STAFF RECOMMENDATION

NCPC File No. 6200

**CLEVELAND PARK METRO STATION
EAST AND WEST ENTRANCE CANOPIES
3599 Connecticut Avenue, NW
Washington, D.C.**

Submitted by the Washington Metropolitan Area Transit Authority

Rendering of Proposed West Entrance Canopy

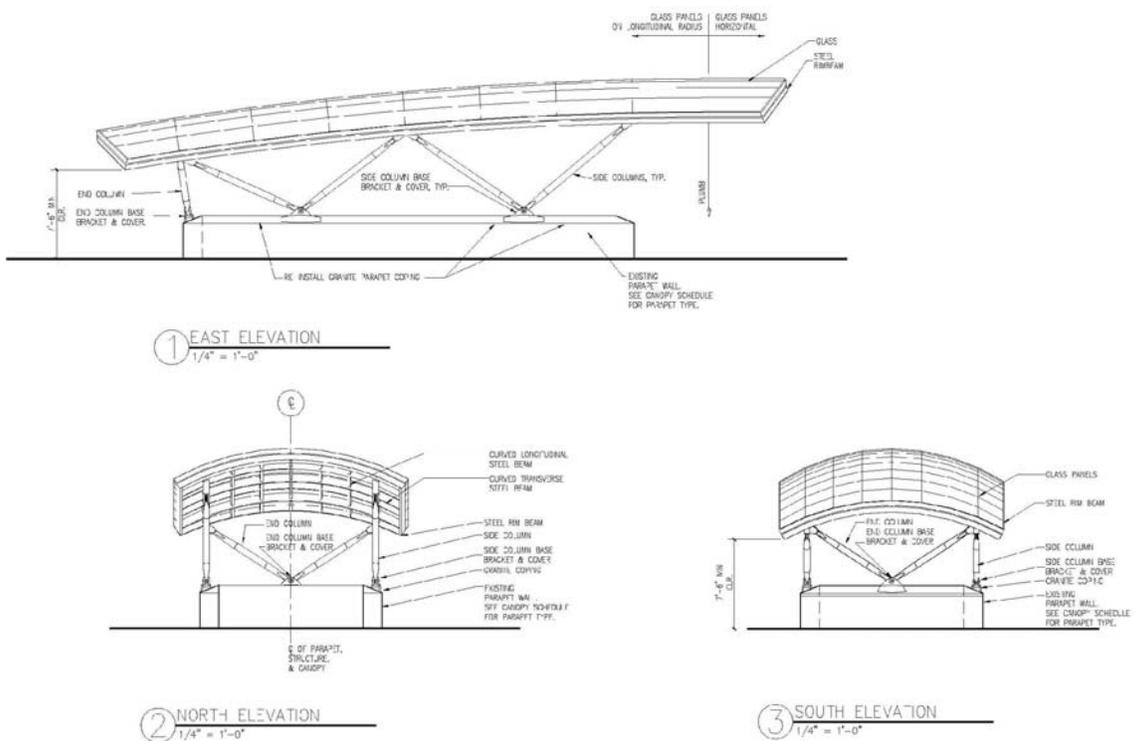
The proposed canopy has been reduced in width from ten transverse bays (as in the standard Metro canopy) to eight transverse bays, while retaining a similar curve to the vaulted form. This rendering is of the proposed west entrance canopy, adjacent to small-scale commercial buildings in the Cleveland Park Historic District.

The modified canopy is designed to continue the established appearance of the system’s standard signature canopy, while responding to the narrow sidewalks and small-scale buildings adjacent to the escalator. The canopy has been narrowed from ten bays to eight bays while retaining the elegant curved form and light appearance recognizable to the public as the signature Metro Station entrance canopy.
